ADDENDUM NO. 1

**Replace Roofs
Guhleman Forensic Complex
Fulton State Hospital
Fulton, Missouri
PROJECT NO.: M1906-01**

PROJECT # M1906-01
ASSET # 6517352026

02 NEW WORK - GUHLEMAN WEST ROOF
A201 1/16" = 1'-0"

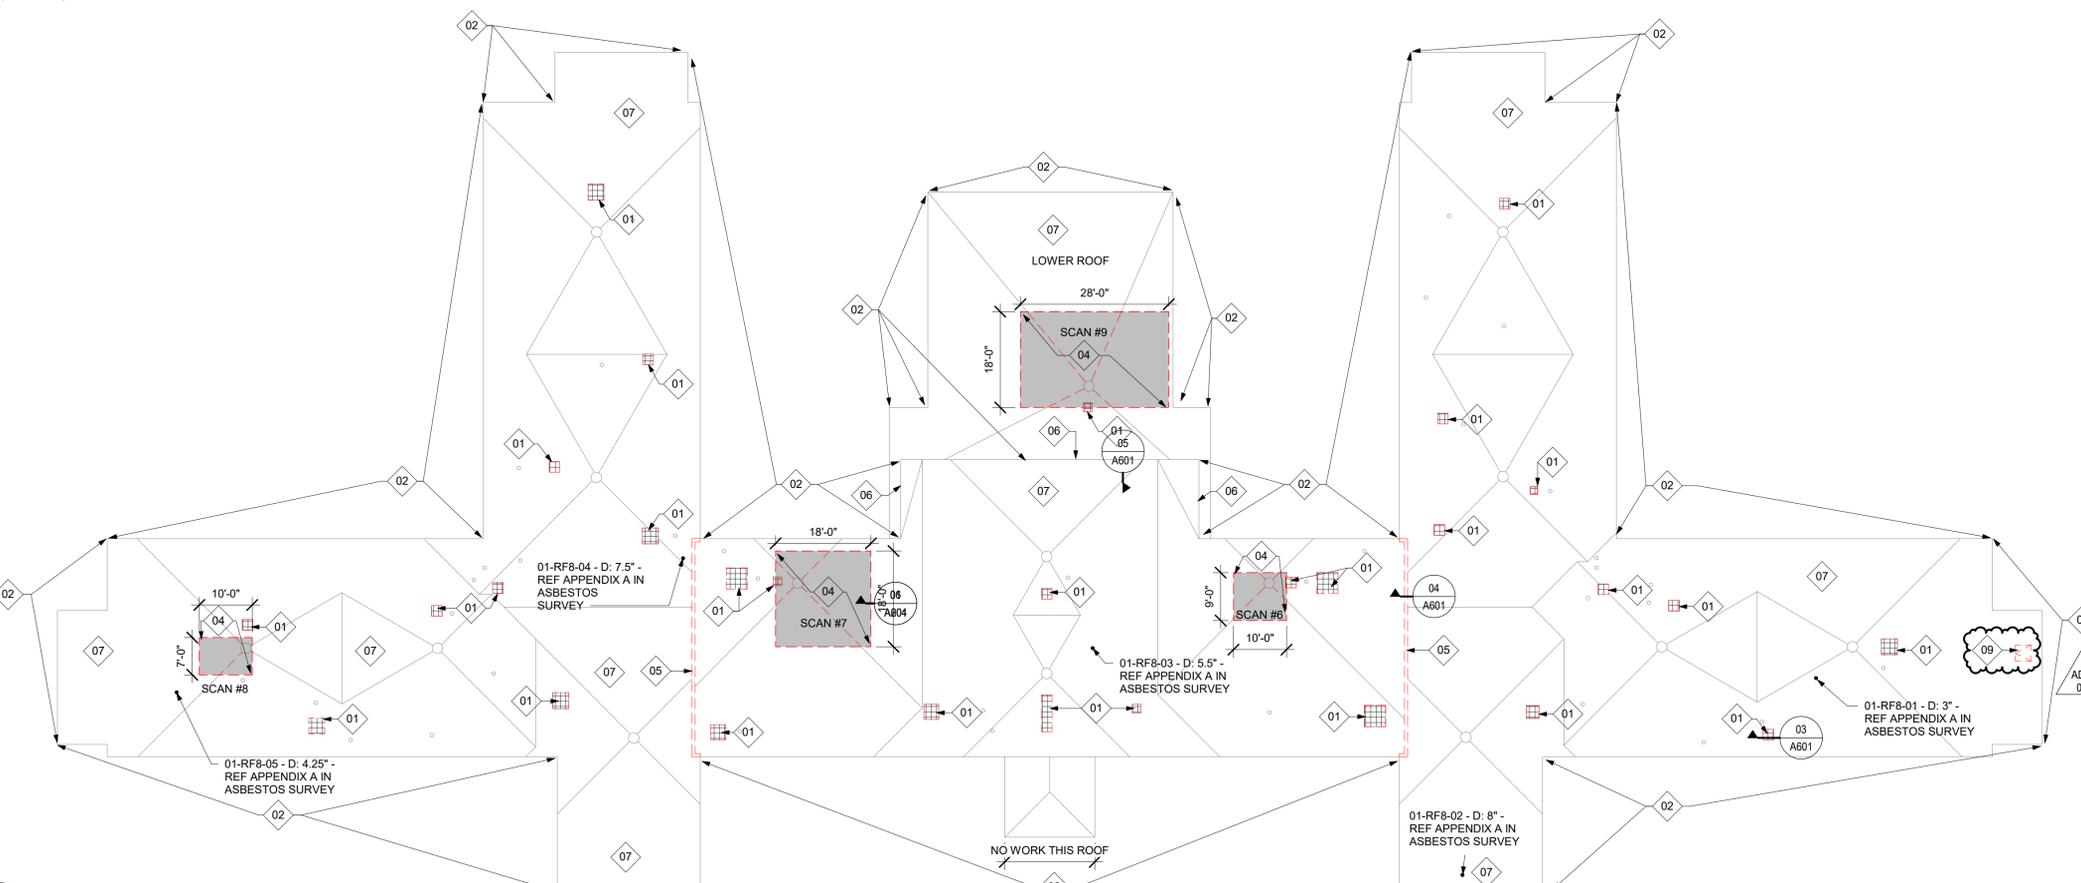
- b. Plan 02 NEW WORK – GUHLEMAN WEST ROOF:
ADD Keynote 10 at roof hatch. (This roof hatch needs to be rotated and reinstalled.)
3. Sheet A202
 - a. Plan 01 DEMO – GUHLEMAN EAST ROOF:
DELETE Keynote 09 at roof hatch and REPLACE with Keynote 03

01 DEMO - GUHLEMAN WEST ROOF
A201 1/16" = 1'-0"

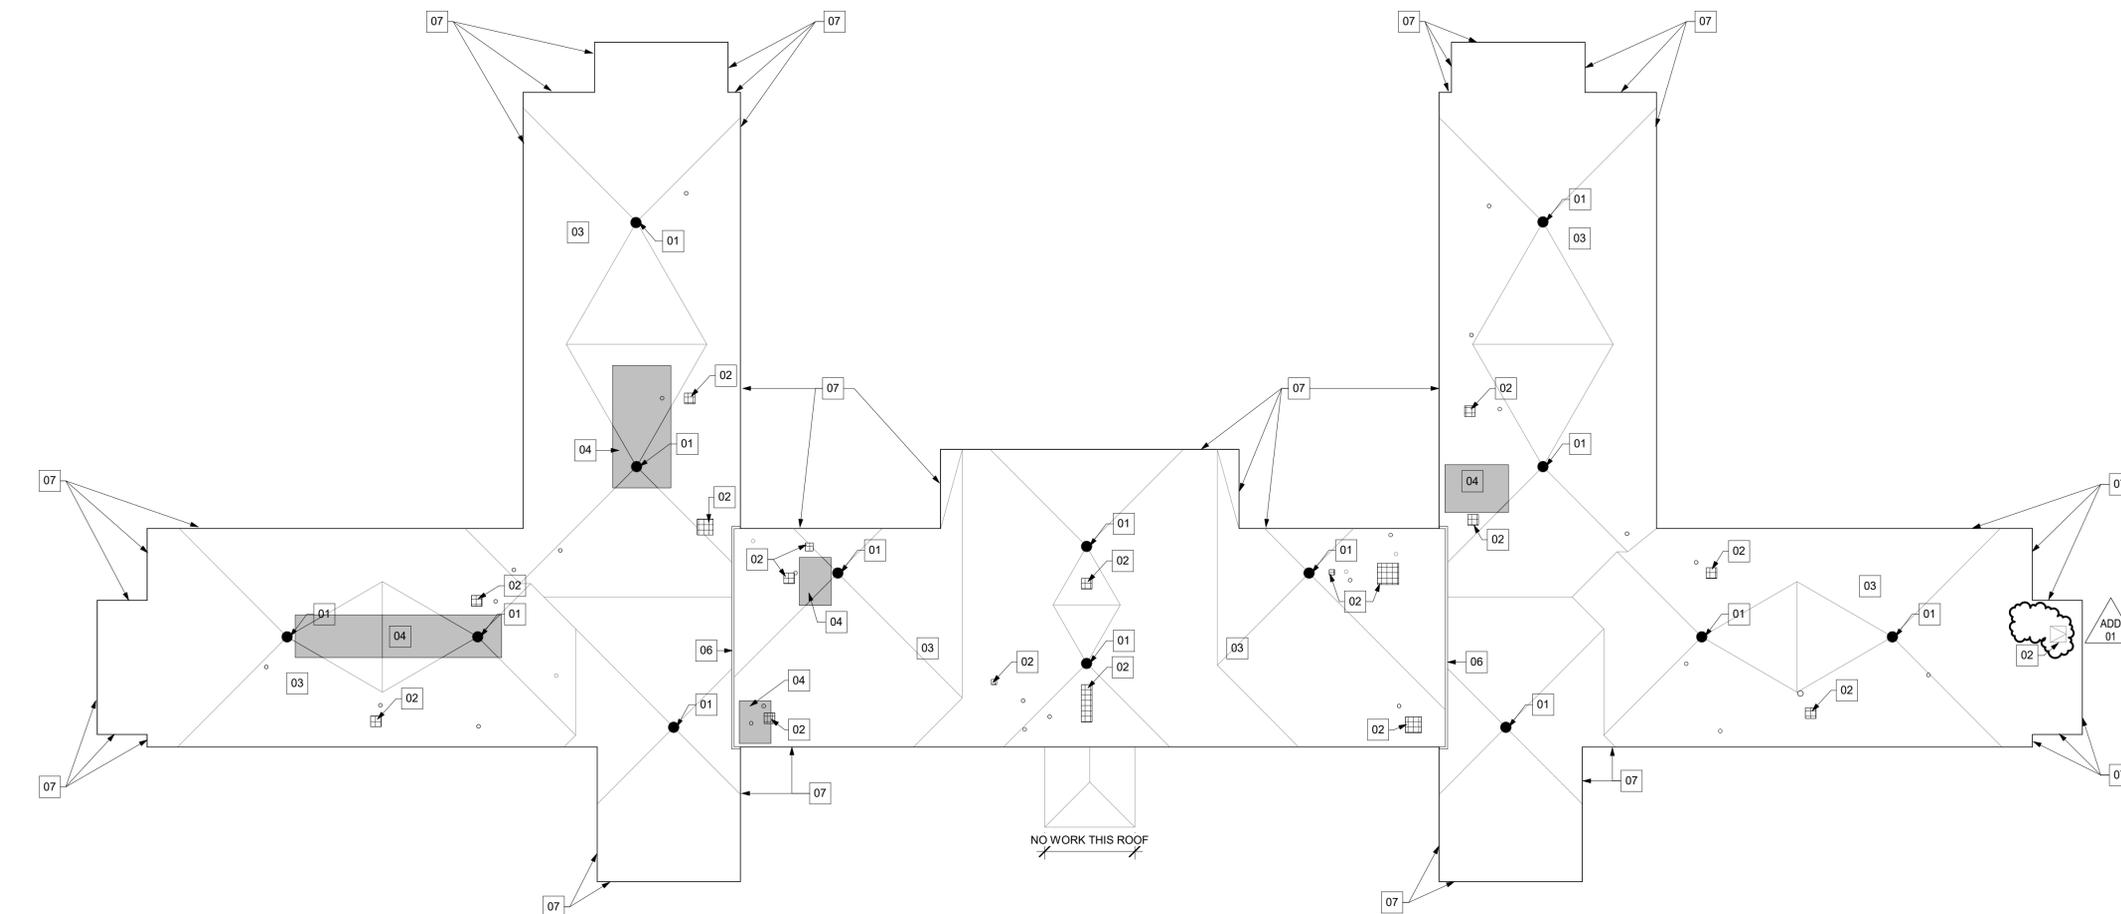
8. REMOVE & SALVAGE DOWNSPOUTS AND SPLASH BLOCKS FOR REINSTALLATION.
2. Sheet A201
 - a. Plan 01 DEMO – GUHLEMAN WEST ROOF:
DELETE Keynote 03 at roof hatch and REPLACE with Keynote 09

04 NEW WORK UPPER ROOF - CREMER ACTIVITY CENTER

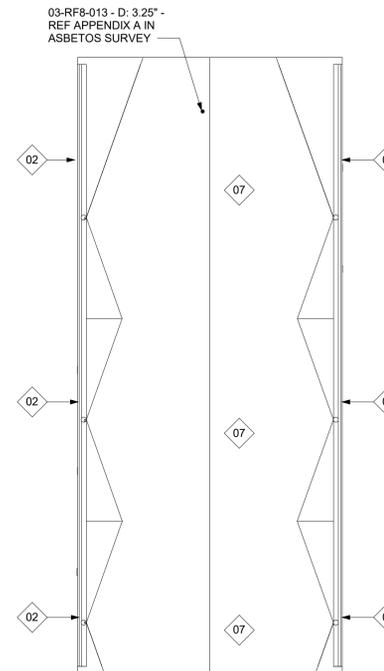
- b. Plan 04:
REVISE title to NEW WORK UPPER ROOF – CREMER ACTIVITY CENTER
REPLACE all Keynote 01 with Keynote 11
5. Sheet A601
 - a. Detail 01 Typ. Roof Drain:

02 NEW WORK LOWER ROOF - CREMER ACTIVITY CENTER

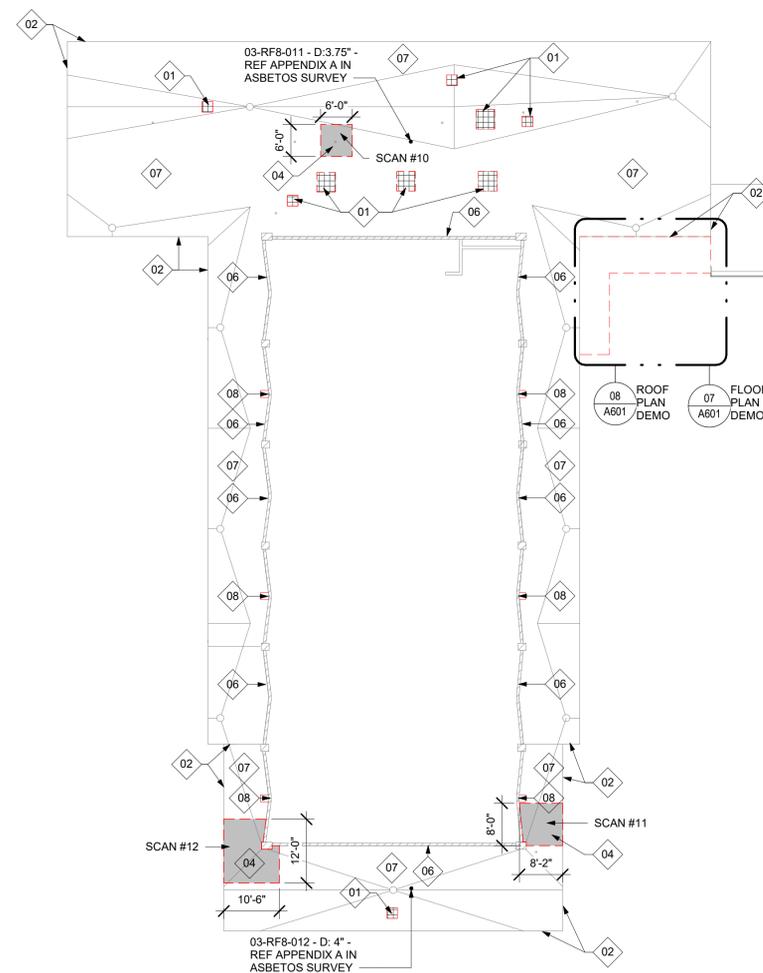
- b. Plan 02 NEW WORK – GUHLEMAN EAST ROOF:
DELETE Keynote 10 at roof hatch. (This roof hatch remains as is.)
4. Sheet A203
 - a. Plan 02:
REVISE title to NEW WORK LOWER ROOF – CREMER ACTIVITY CENTER
REPLACE all Keynote 01 with Keynote 11

05 FLASHING DTL

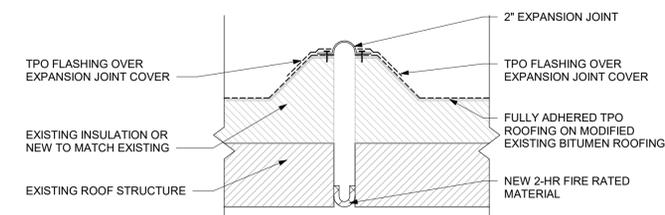
- b. Detail 05 Flashing Dtl:
DELETE reference to two-piece flashing.

01 TYP. ROOF DRAIN

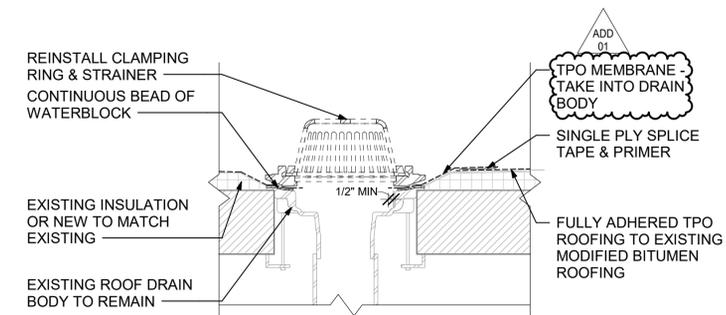
REVISE note to REPLACE WHITE EPDM with TPO.

(For clarification, the TPO membrane is to be tan, not white.)
